## Planning Officer's Report – LDCA JUNE 2021

<b>APPLICATION</b>	<b>2021/41</b> – Proposed Change of Corrugated Iron to IBR Sheeting & Install Photovoltaic Panels
<b>PERMISSION SOUGHT</b>	Permission in <b>Full</b>
<b>REGISTERED</b>	11 <sup>th</sup> May 2021
<b>APPLICANT</b>	Gregory Cairns-wicks
<b>PARCEL</b>	JT040017
<b>LOCALITY</b>	Rear of Essex House, Jamestown
<b>ZONE</b>	Intermediate
<b>CONSERVATION AREA</b>	Jamestown Conservation Area
<b>CURRENT USE</b>	Dwelling in construction
<b>PUBLICITY</b>	The application was advertised as follows: <ul style="list-style-type: none"><li>▪ Sentinel Newspaper on 13<sup>th</sup> May 2021</li><li>▪ A site notice displayed in accordance with Regulations.</li></ul>
<b>EXPIRY</b>	27 <sup>th</sup> May 2021
<b>REPRESENTATIONS</b>	None Received
<b>DECISION ROUTE</b>	<del>Delegated</del> / <b>LDCA</b> / <del>EXCO</del>

**Diagram 2 and 3: Layout of Panels & Elevations**

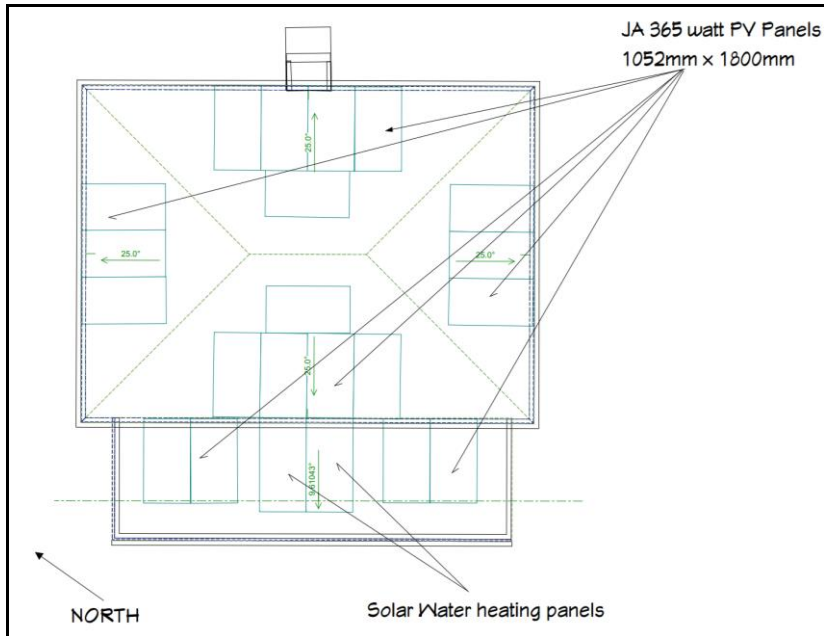
'From the Castle Gardens this roof will be visible in the same view as the proposed panels on the old cinema roof therefore a consistent approach would be advisable. The Heritage Society would therefore recommend the same design approach that led to the revised application for the old cinema. As such the two upper horizontal panels should be omitted, leaving 4 and 3 panels on each of the opposing sides of main hipped roof. Any changes to the roof colour needs to be carefully considered in relation the LDCP roofing policy for the conservation area.'

In assessing this particular proposal for the photovoltaic panels, it was considered that the siting of the panels would not be acceptable in their current format. The officers advised the applicant that the panels should be sited further away from the roof edge on all elevations to provide a perimeter of sheeting around the panels, where the

applicant was content with this request. The officers then advised that the two horizontal panels on the west and east elevations should be omitted to ensure a more coherent appearance. The idea is to have the panels become a feature within the roofscape without having any adverse visual impact particular from vantage points such as the viewing platform at Jacobs Ladder or even the Castle Gardens. The applicant stated that the number of panels proposed had been calculated to ensure both dwelling units can operate completely off-grid, therefore removal of these two panels would have an impact on the ability to achieve their objective. There is a possibility that the panels could be sited vertically alongside the other four panels, which would mean the end panels being approximately 100 – 200mm away from the hip rafters of the roof. The applicant was of the opinion that he did not want to site the panels in close proximity to the hip of the roof, along with the uncertainty of how they may look.

In conclusion, the change of sheeting from the previously approved profile of corrugated iron to IBR as well as the principle of photovoltaic panels on the building can be supported, however to ensure the best possible design for that building and to remedy its impacts on the setting of the conservation area, these two panels in the officers opinion needs to be relocated or alternatively a more powerful system, which relies on a reduced number of panels should be installed.
